A PRELIMINARY REPORT  
**PLANS**  
For EXTENSION and  
ENLARGED APPROACHES  
TO  
**NEW PASSAIC RIVER BRIDGE**

CENTRAL PLANNING BOARD  
OF THE CITY OF NEWARK, NEW JERSEY

October 25, 1944

PRELIMINARY PLAN FOR NEW PASSAIC RIVER  
BRIDGE AS PROPOSED BY NEW JERSEY STATE HIGHWAY DEPT.

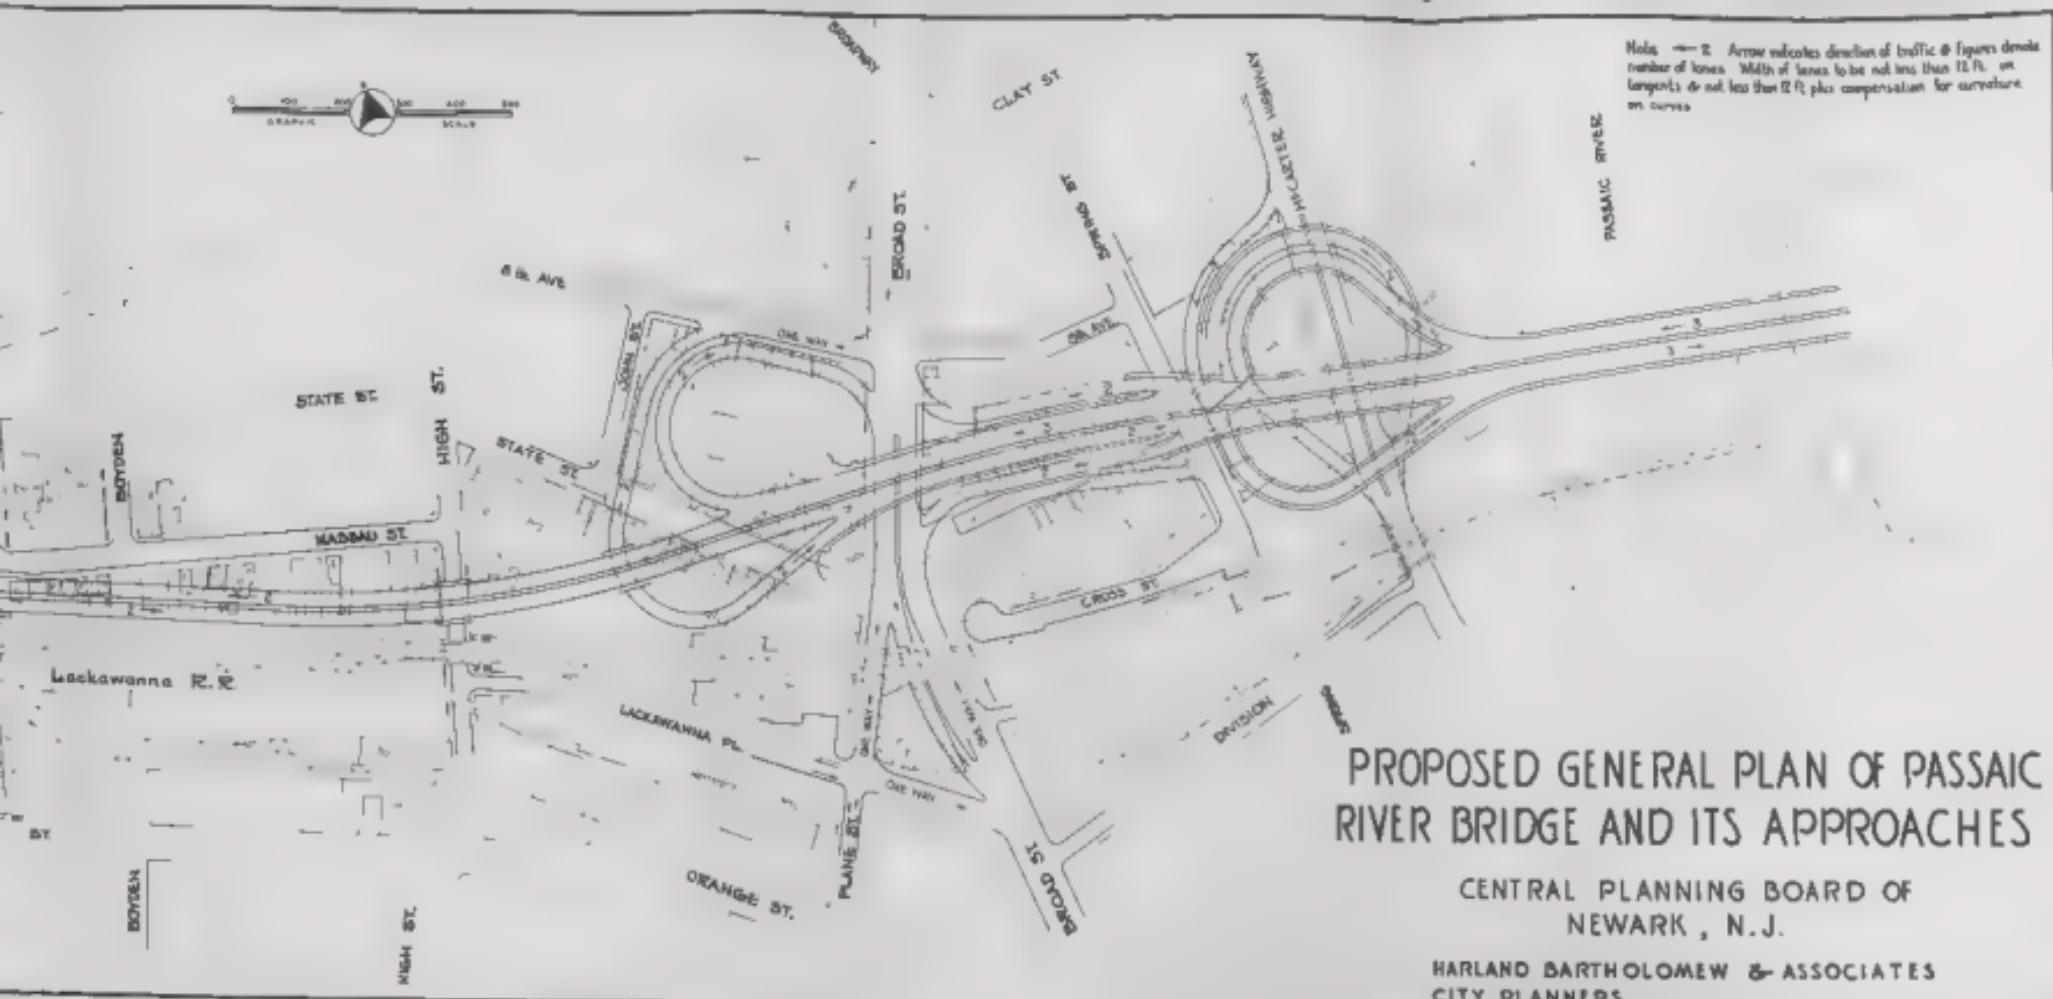
One of the most difficult and complicated traffic situations in Newark today exists at the intersection of Broad, Cross, Grant, State and Penn Streets in vicinity of the Lackawanna Railroad Station. Because of the fact that it is intersecting at this point, there is a great variety of traffic moving about, many of which conflict with one another. There are also many passengers moving into the Lackawanna Station, particularly from Mortons who board on Broad Street discharging passengers at the Station. It would seem most advisable to make a complete traffic regulation by introducing a large volume of traffic from the Bridge into this intersection as proposed by the State Highway Department. (See Plate No. 3)

The traffic discharged from the Bridge at this point was determined on Penn Street is estimated at 600 during the maximum hour. This traffic will enter Broad Street via State Street directly under the Bridge and directly north of the present Lackawanna Station, thus adding to the complication now existing at this point. For east bound traffic on Broad Street wishing to proceed on the Plaza, there is provided a direct turn-off directly west of Cross Street. It is estimated that during the peak hour, approximately 720 vehicles will wish to enter the Plaza from Broad Street. It is probable that because of interference with

Cross Street traffic, such traffic would block through traffic on Broad Street at certain times of the day.

Attention also should be called to the fact that no provisions are made for southbound Broad Street traffic to enter the Bridge going east. It is possible for this traffic to use the entrance ramp for northbound traffic on Broad, but, in so doing, it would necessarily make a 1 ft turn prior to entering traffic, thus resulting in confusion and delays. The only other way for this traffic to reach the Bridge would be to use the High Street entrance ramp.

The exit ramp from the Bridge to Broad Street connects directly in reaction of South Street and High Street. The existing street is wide from this point to Broad. An stated previously this traffic would become immediately critical point in the Broad Street traffic stream.

The system of ramps connecting the Bridge to High Street do not present the serious problems that will be created at Broad Street, due to the fact that there is more room to negotiate the turns by these ramps and there is no anticipated local traffic. The lone exception being the connection to Prospect Street near the intersection of this road. The principal criticism for this section of the Bridge is that no provisions are made for southbound traffic

To meet the above objections, the Planning Board has prepared the plan shown on Plate No. 4.

Because of the expense of acquiring rights of way, the State Highway Department has located the Bridge as closely as possible to the Lackawanna Railroad from McCarter Highway to Broad Street. This cramped location results in the objectionable features described in the preceding section.

It is recommended that the entire structure be moved northward between McCarter Highway and High Street in order to provide room for adequate connections from the City streets to the Bridge. There is no change in location recommended west of High Street or east of McCarter Highway. To facilitate movements to and from the Bridge in the vicinity of Broad Street and the Lackawanna Railroad Station, the following recommendations are made:

(a) Traffic from the Bridge southbound on Broad Street should be discharged at a point near Eighth Avenue and Broad Street rather than at State Street as proposed by the Highway Department. This would give an opportunity for such traffic to merge with the through traffic on Broad Street instead of getting mixed up with the complicated

## PLAN A

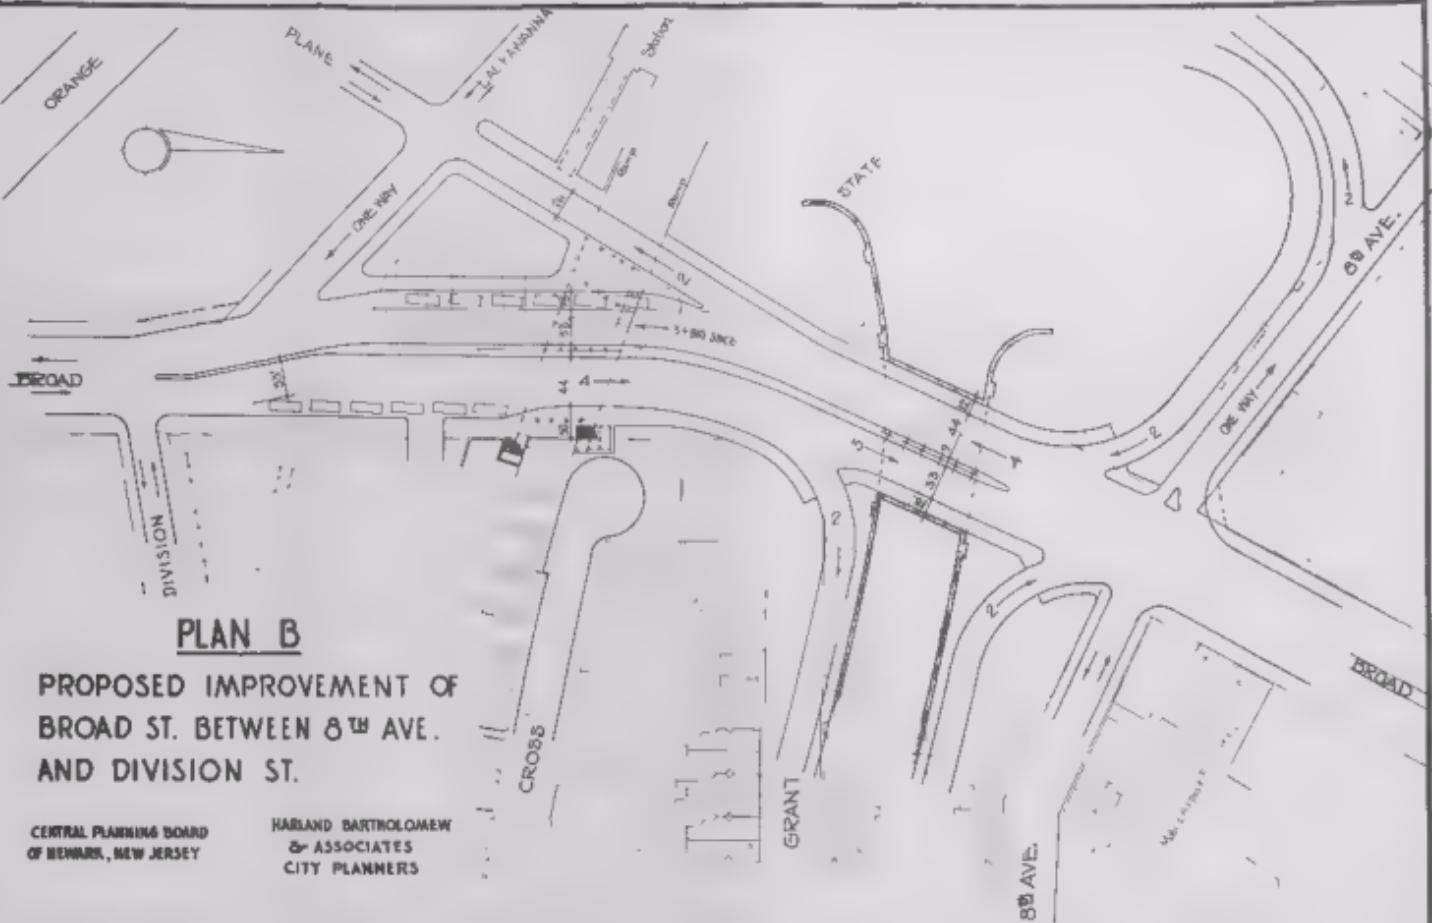
Alternative improvements are shown on Plates Nos. 5 and 6. Under Plan A, it is proposed to provide the connections described above, and also make it possible to segregate the through traffic from slow moving busses and trucks on Broad Street. To avoid conflicts from traffic entering Broad Street from the existing local streets in that vicinity, it is recommended that Cross Street be closed at Broad and turnarounds provided near Broad Street; that Grant Street be relocated and terminated at Broad Street; that State Street be closed between John and Plane Streets, and that Plane Street be one-way as it is at present; Lockwood Place, and that Lockwood Place be made one-way between Plane Street and Broad Street.

The proposed improvements include widening of Broad Street between Lockwood Place and Eighth Avenue to provide four lanes of moving traffic northbound plus an additional lane for the unloading of busses on the east side of Broad Street between Division Street and the Lockwood Railroad and to provide four lanes of moving traffic southbound between Eighth Avenue and the intersection of Broad and Plane Streets where there would be a separation of thru-traffic and bus traffic. It is also proposed to widen Plane Street from State Street to Lockwood Place to provide a bus loading and unloading zone plus two moving lanes of traffic.
